North Dakota Department of Transportation

PLAN REVISION PROJECT NO. F-RRS-1-006(005)066

PLAN and/or CONTRACT REVISION

PROJECT NO.: F-RRS-1-006(005)066
 COUNTY: Morton
 CONTRACTOR: Northern Improvement
 DATE: January 18, 1991

TRAFFIC CONTROL SYSTEM
 Combination Lighting & Signal
 Pad Mtd. Feed Point Detail
 Sta. 737+45-46' Rt.

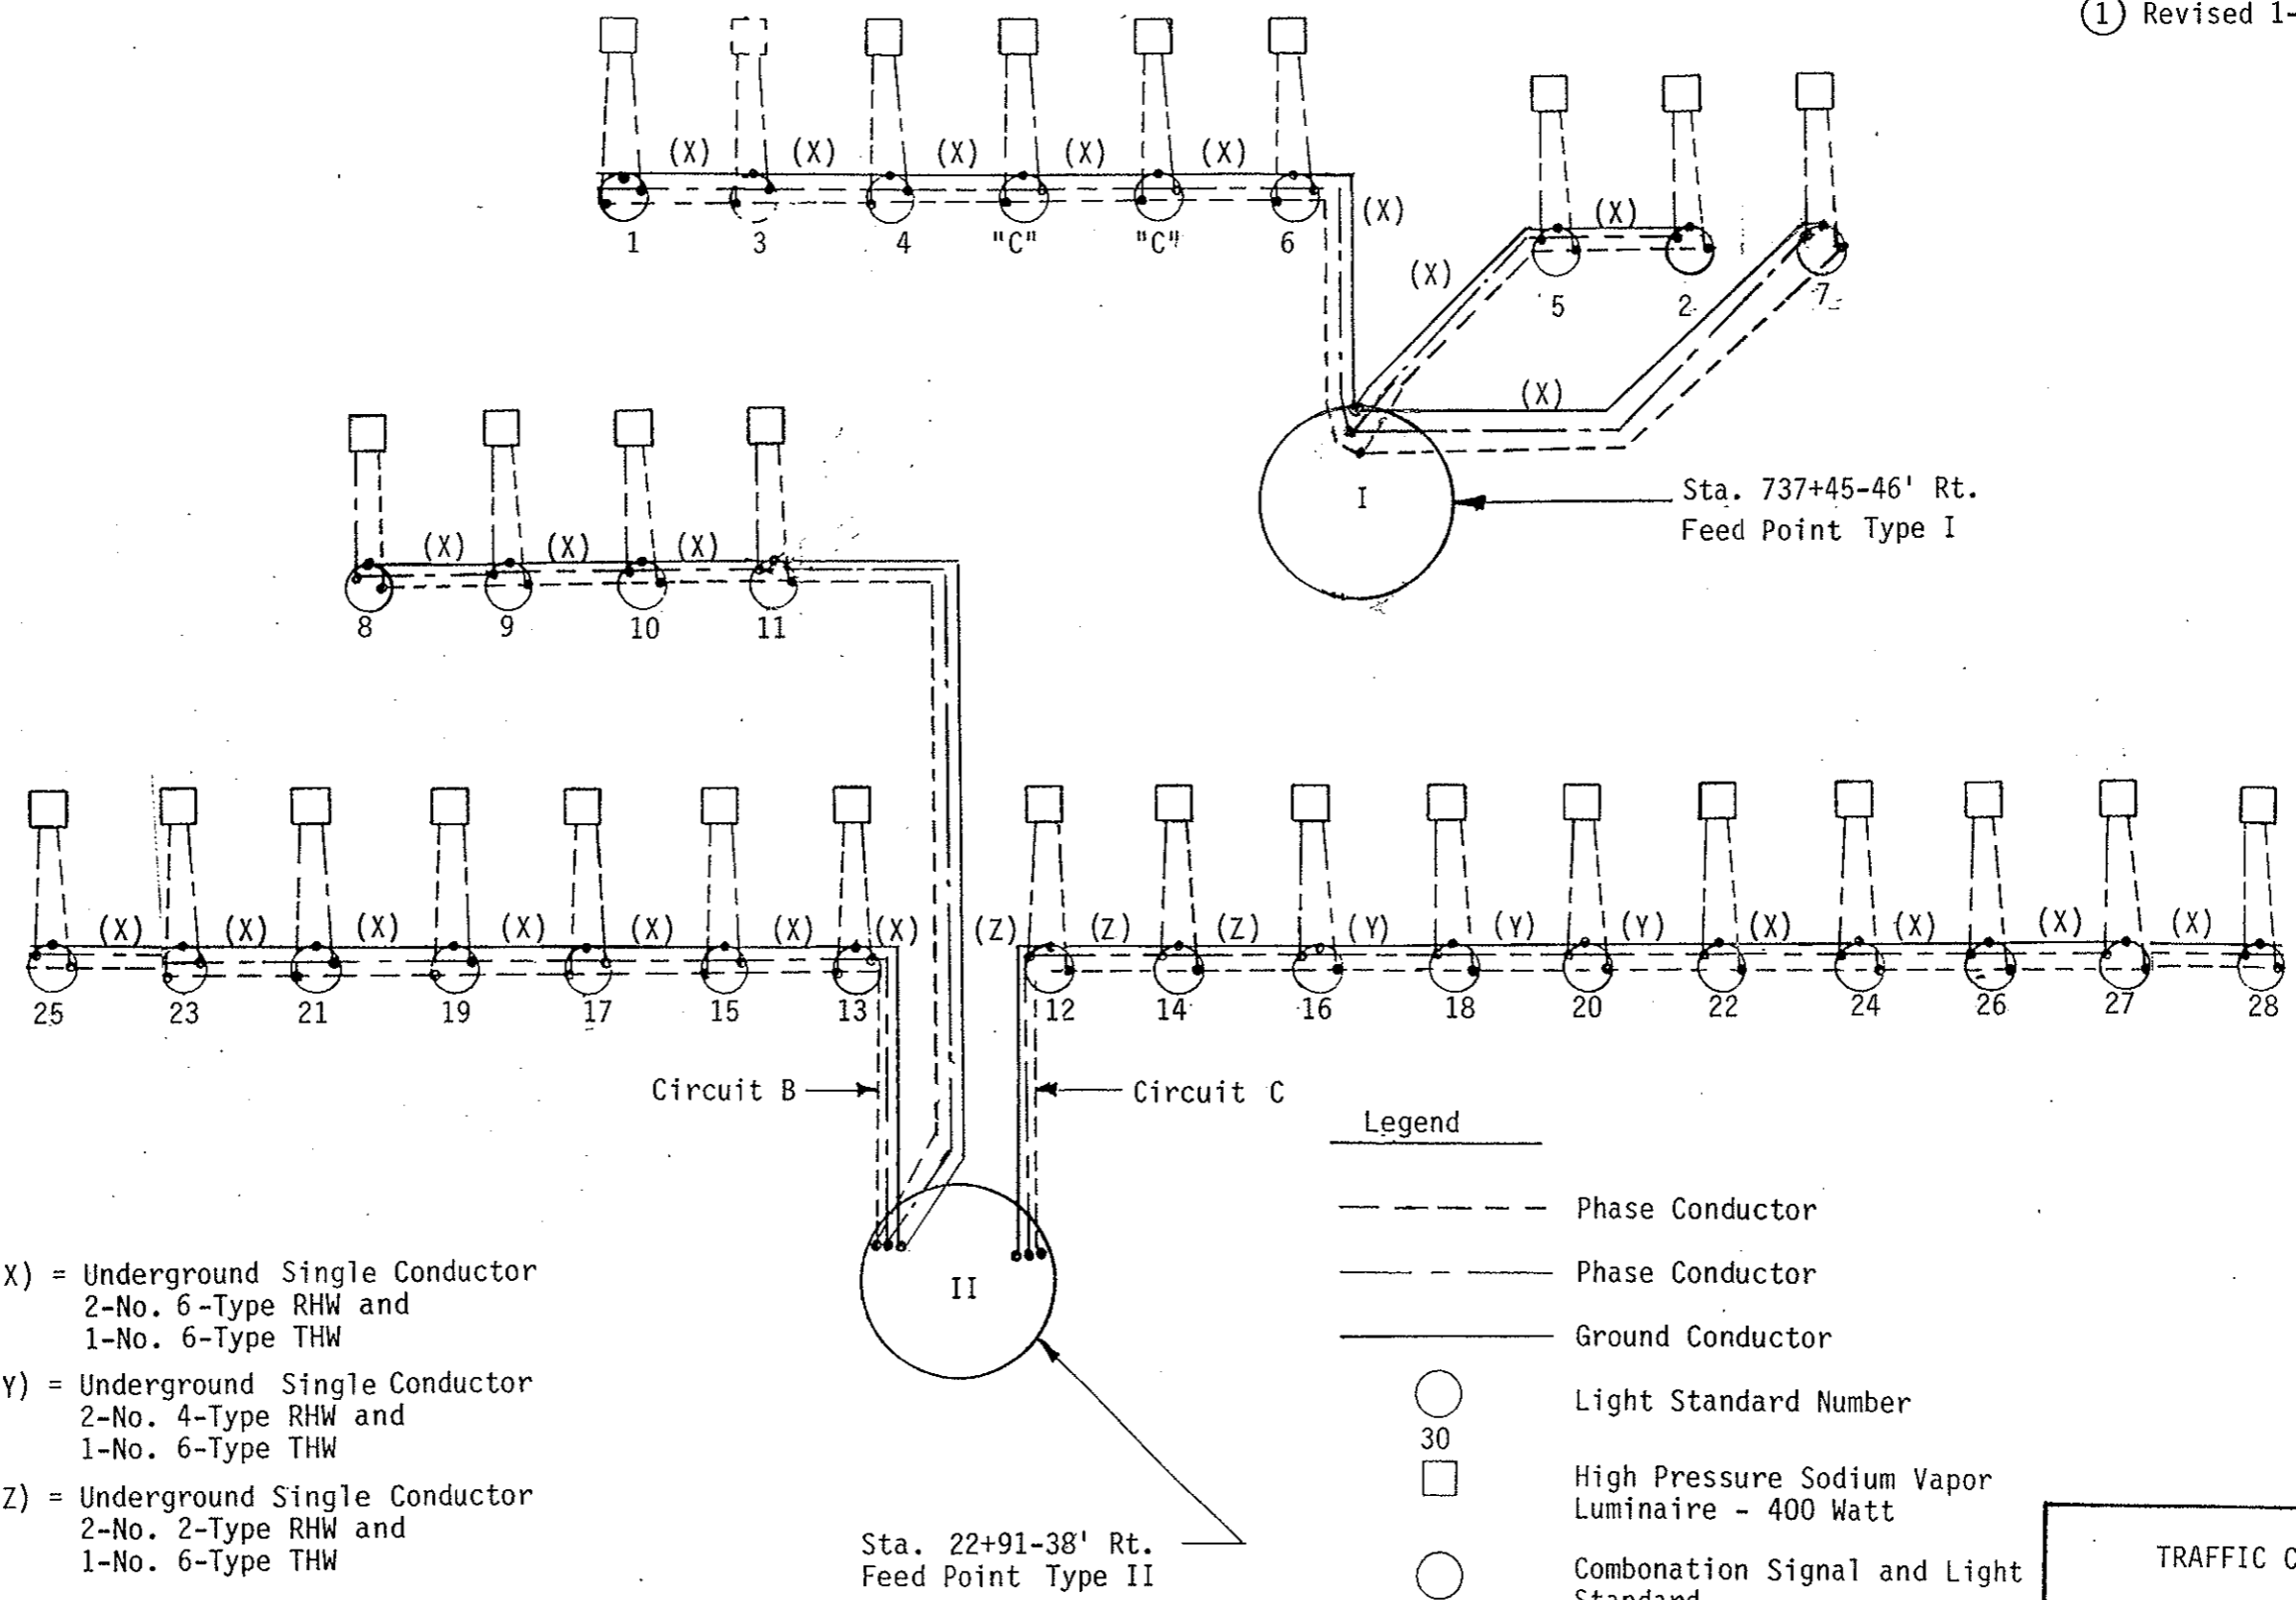
Sheet 143: Revised feed point details.

Sheet 143: Revised feed point details.

Lighting System Schematic
Feed Point I and
Feed Point II

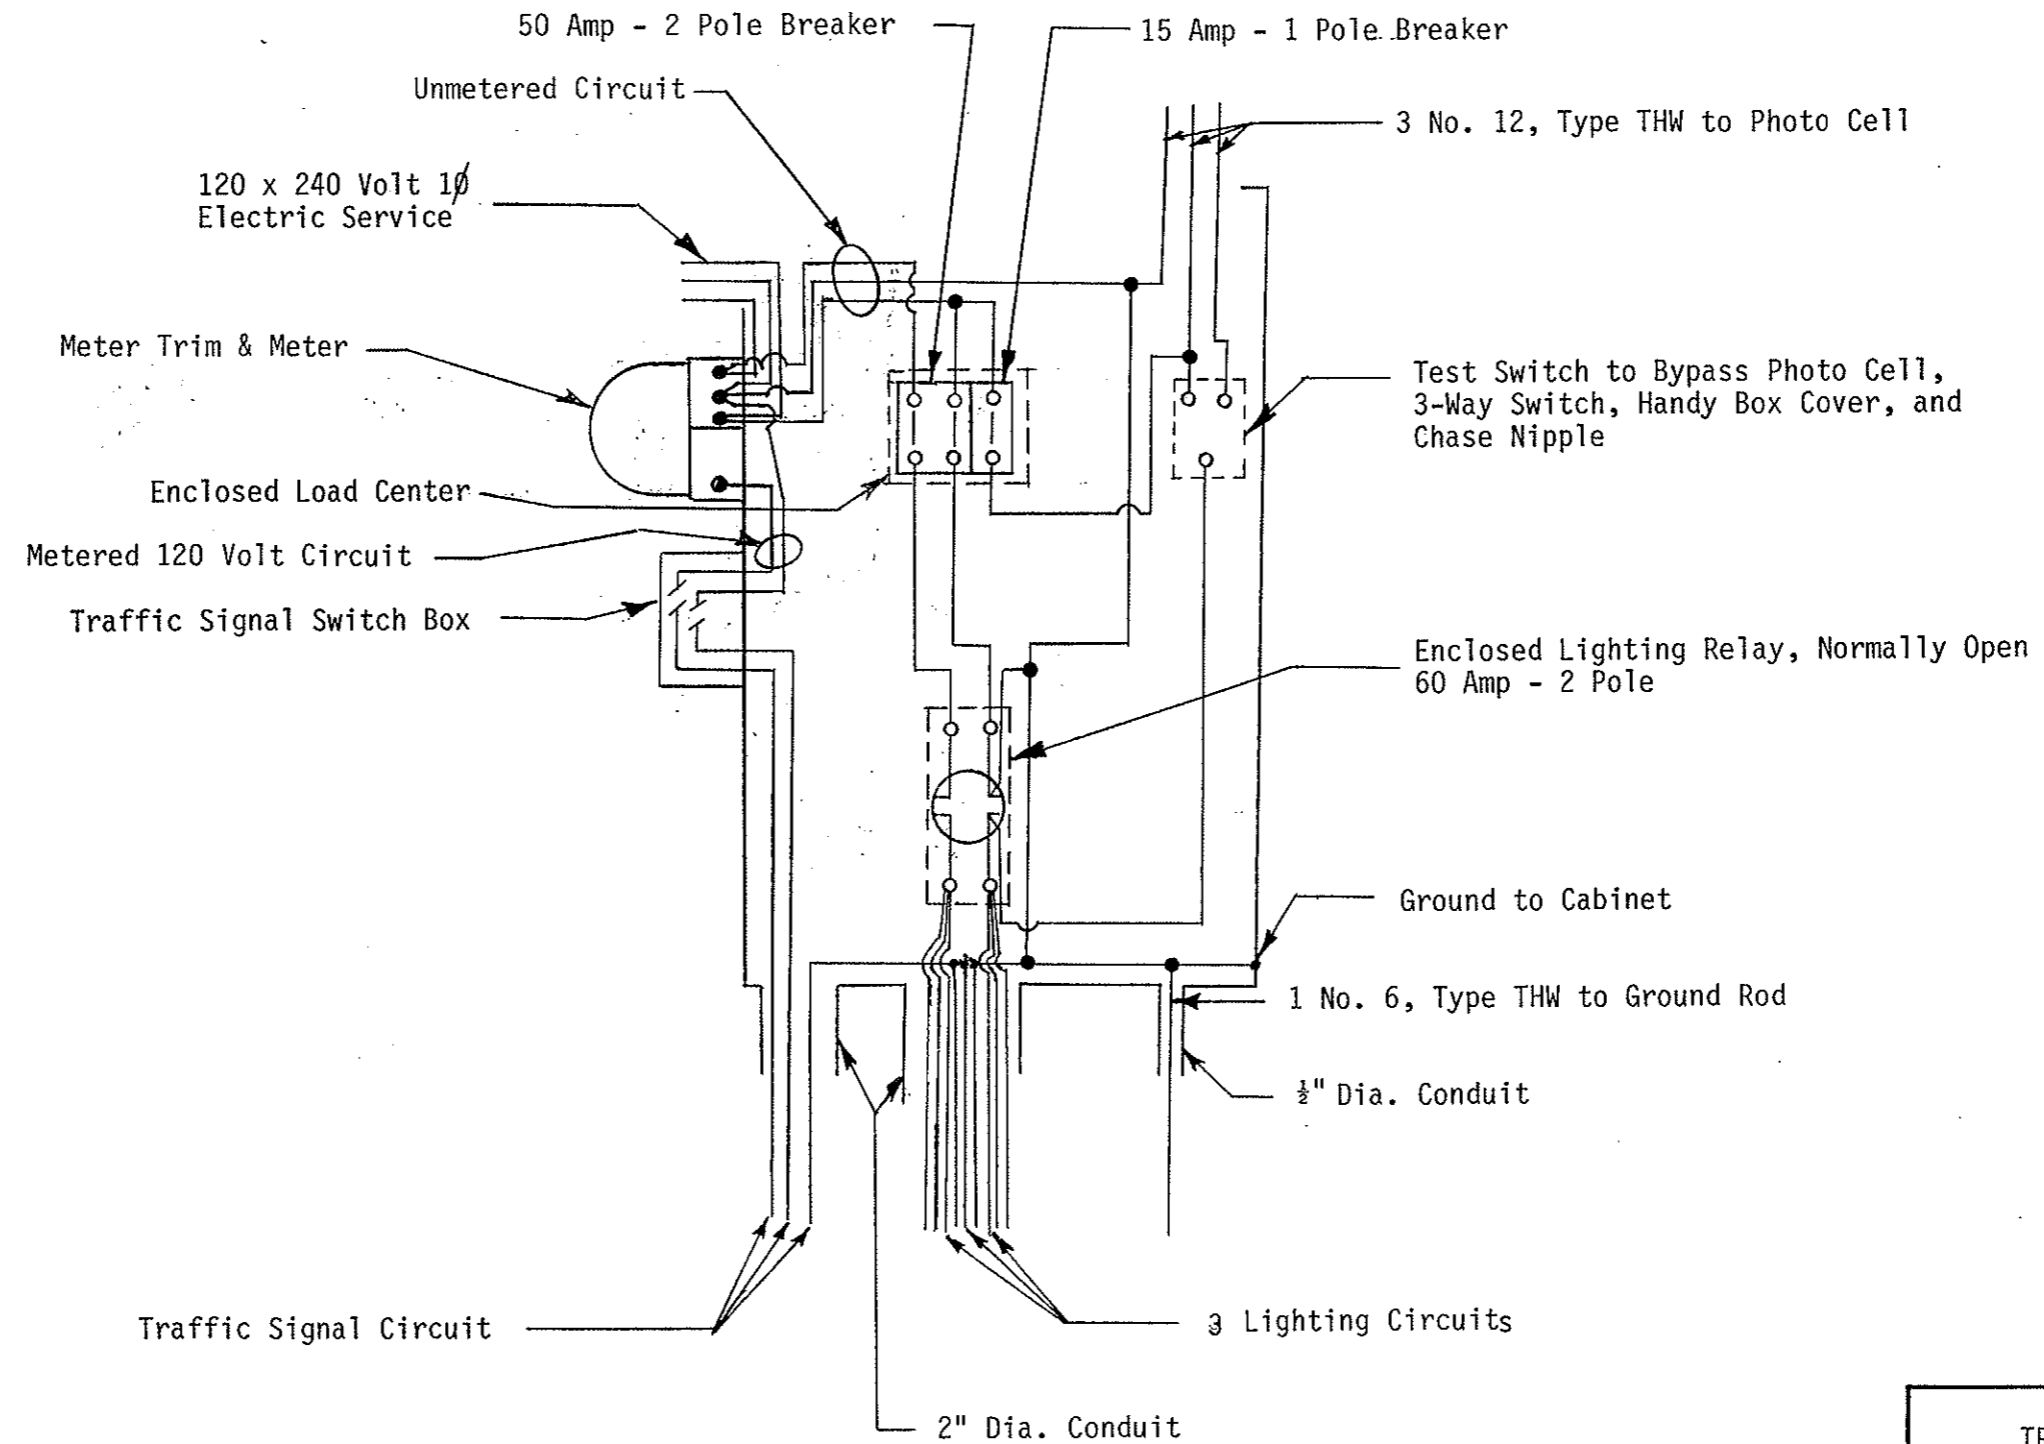
Sheet 145: Revised Lighting Schematics from light standard 11 to 8.

Sheet 145: Revised Lighting Schematics from light standard 11 to 8.
